LOT 10 ON DIAGRAM 13503
 REDMILE ROAD, YORK

DA ASSESSMENT REPORT

DA No. P933
Address: Lot 10 (1) Redmile Road, York
Proposal: Swimming Pool and Fencing

APPENDIX 2 – TECHNICAL DRAWING

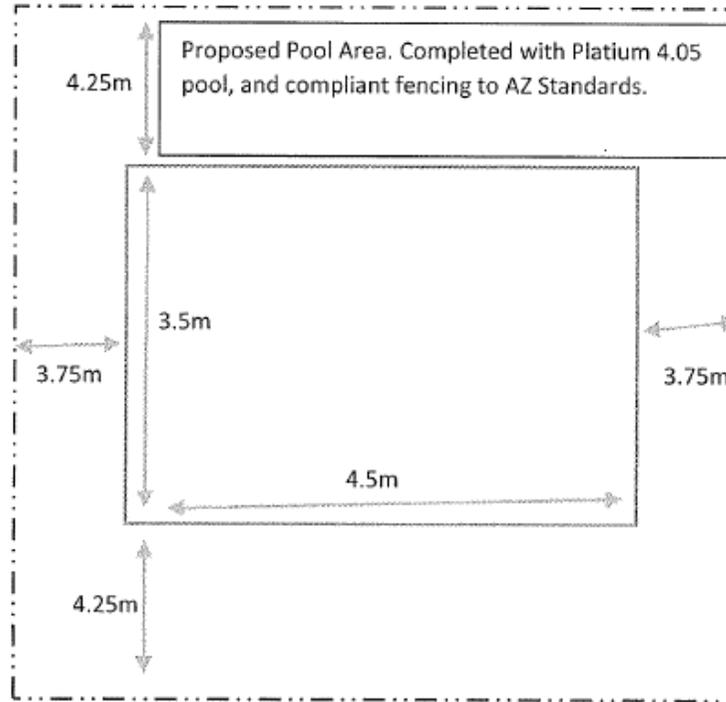
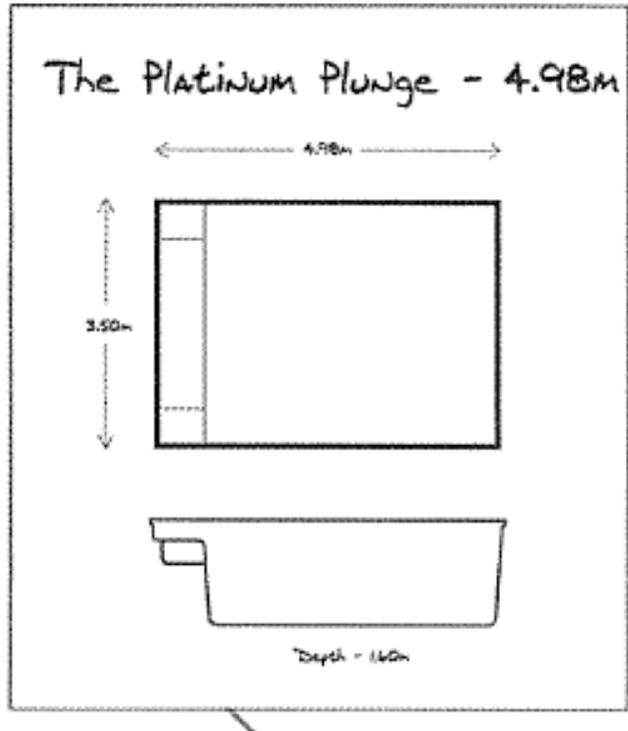
The proposed swimming pool will be a 12 metre by 12 metre structure, with a setback of 8.2 metres at it closest. As noted above this variation in setbacks is to accommodate the development outside the floodway/floodfringe and avoid the removal of vegetation. Clause 4.15.2 of the scheme states developments are to have regard to the scenic value of the district and views from the roads. The proposed swimming pool will not be visible from public realm therefore will have limited impact on the scenic values of the district and the views from roads.

A fence constructed of brick/timber pillars and corrugated iron is proposed. No elevations have been provided for this.

- (v) **Whether adequate provision has been made for the landscaping of the land to which the application relates and whether any trees or other vegetation on the land should be preserved.**
The application in its current form does not incorporate landscaping, which should be provided to ensure adequate screening of the development as viewed from the adjacent Balladong Farm.

APPENDIX 3 – FLOOD MAP

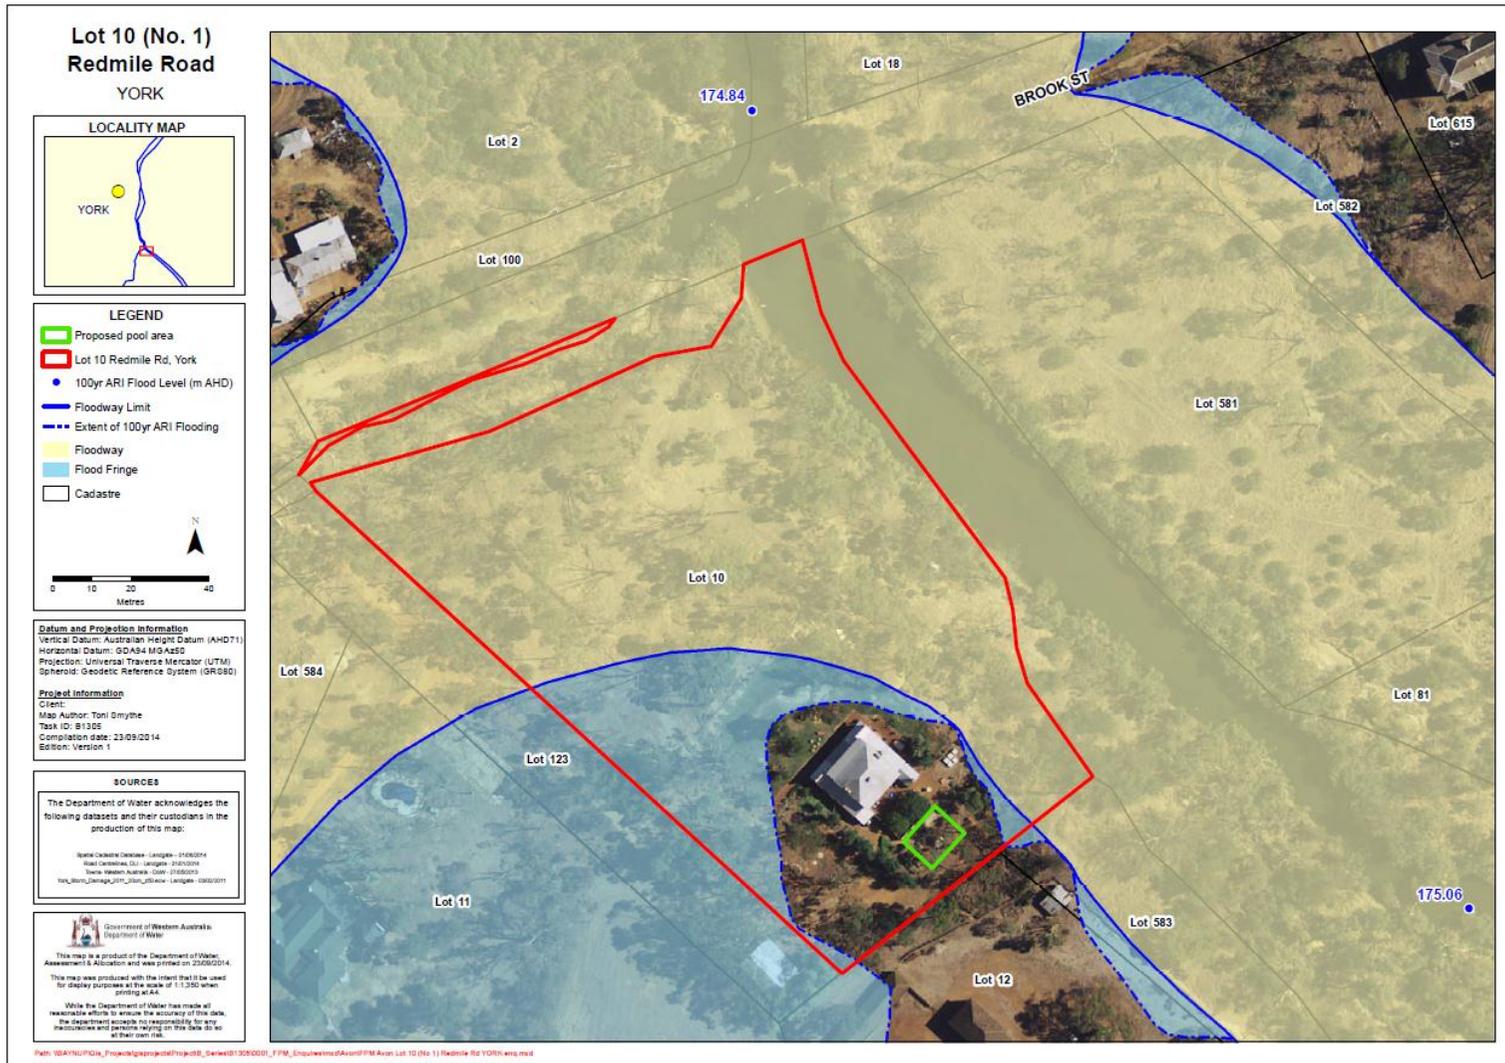
The Avon River Flood Study shows that a portion of the lot is affected by flooding during major river flows with the 100 year ARI flood level estimated to be ~175 m AHD (see attached plan). Based on our floodplain management strategy for the area:

The proposed pool area is located outside of the floodway and consequently is considered acceptable with respect to major flooding.

- Proposed development (i.e. filling, building, etc) that is located outside of the floodway is considered acceptable with respect to major flooding. However, a minimum habitable floor level of 0.5 m above the appropriate 100 year ARI flood level is recommended to ensure adequate flood protection.*
- Proposed development that is located within the floodway and is considered obstructive to major flows is not acceptable as it would have a detrimental impact upon the existing flooding regime. No new buildings are acceptable in the floodway.*
